BOARD AGENDA

Planning Board Regular Meeting - Tuesday, April 14, 2015 - 6:00 p.m.
City Hall - City Commission Chambers, 100 North U.S. #1, Fort Pierce, Florida

Site Plan - O'Reilly Auto Parts - 2600 Okeechobee Road

**Re: Technical Review - Site Plan Review
O'Reilly Auto Parts – 2600 Okeechobee Road & 27th Street
Project #: 14-07000005**

SITE DEVELOPMENT PLAN

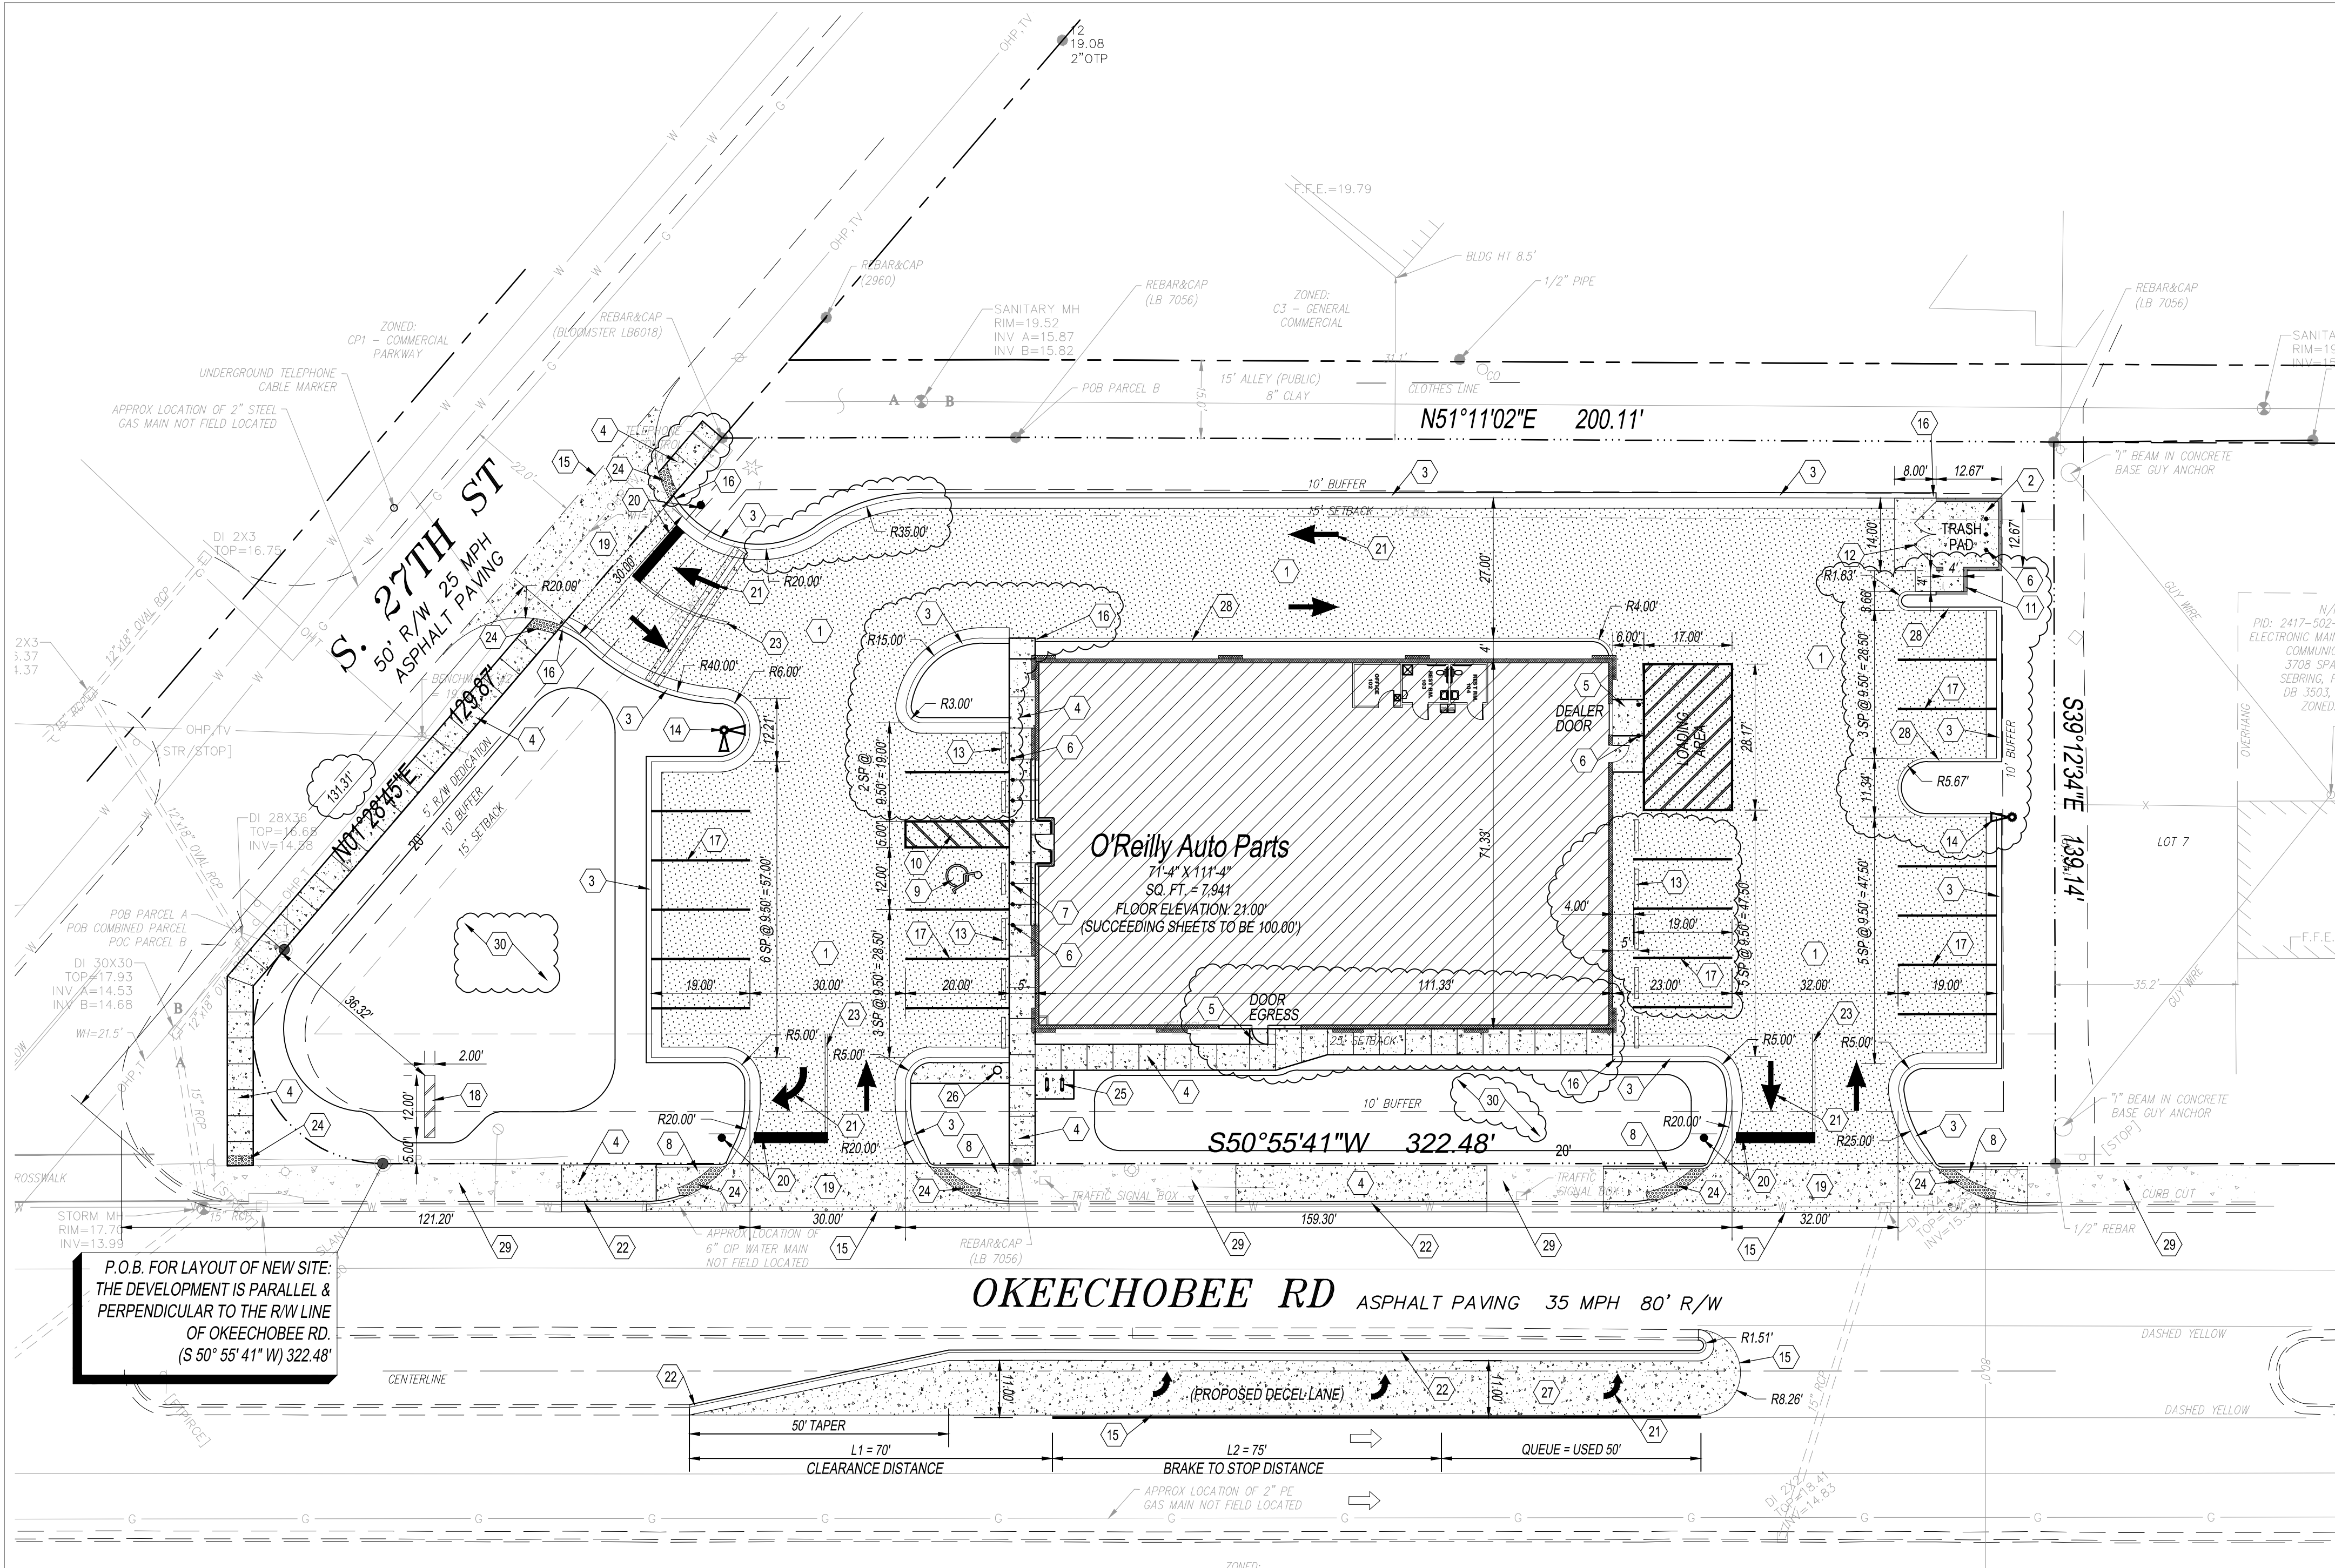
3. The site plan shall indicate the location of the detention areas.

6. Provide the sidewalk width and the parking space stall lengths for the five (5) parking spaces located on the east side of the building.

Response 3. Stormwater management ponds have been added and keynoted.

Response 6. Requested dimensions have been added to the Site Development Plan (Sheet C-6).
